Access Compliance Report

Public Rights-of-Way

Intersection ID: 49149	Main Street: OLD_PROVIDENCE_LN	Cross Street: DACAVIN_DR	Location: SW
ADA ID: 672F0D7C2D30	Ramp Type: ParaDiag	Initial Pass/Fail: Fail	Overall Compliance: No
		Severity Score: 10

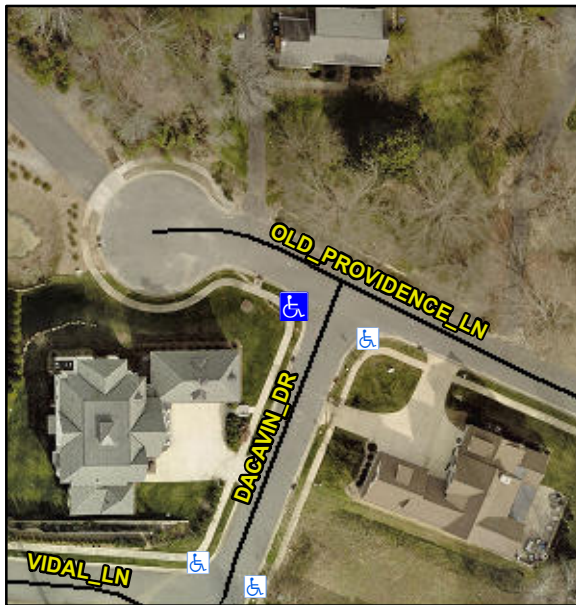
RT RP < 5%

R304.5.1, R304.5.3

Compliance	Description	Data	Compliance	Description	Data
N/A	Ramp Length LT (in)	52.0	N/A	Ramp Length RT (in)	48.0
Yes	Ramp Width LT (in)	48.0	No	Ramp Width RT (in)	47.0
Yes	Ramp Slope LT (%)	5.8	Yes	Ramp Slope RT (%)	2.4
No	Ramp XSlope LT (%)	3.2	No	Ramp XSlope RT (%)	2.2
N/A	Landing Length (in)	N/A	N/A	DWS Provided?	N/A
N/A	Landing Width (in)	N/A	N/A	DWS Contrast?	N/A
N/A	Landing Slope (%)	N/A	N/A	DWS Length (in)	N/A
N/A	Landing X Slope (%)	N/A	N/A	DWS Full Width?	N/A
N/A	Landing Curb? (Y/N)	N/A	N/A	DWS Offset (in)	N/A
N/A	Shared Landing?	N/A			
N/A	Gutter Ponding?	N/A	N/A	Gutter Slope (%)	N/A
N/A	Gutter Lip Ht (in)	N/A	N/A	Gutter X Slope (%)	N/A
N/A	Painted X Walk1?	No	N/A	Painted X Walk2?	No
	X Walk 1 Direction	To SE		X Walk 2 Direction	To N
N/A	X Walk 1 Width (in)	N/A	N/A	X Walk 2 Width (in)	N/A
	X Walk 1 Slope (%)	2.1		X Walk 2 Slope (%)	1.9
	X Walk 1 X Slope (%)	2.2		X Walk 2 X Slope (%)	3.1
N/A	Ramp inside XWalk1?	N/A	N/A	Ramp inside XWalk2?	N/A

Remove & Replace Curb Ramp With Two New Directional Ramps or Equivalent.
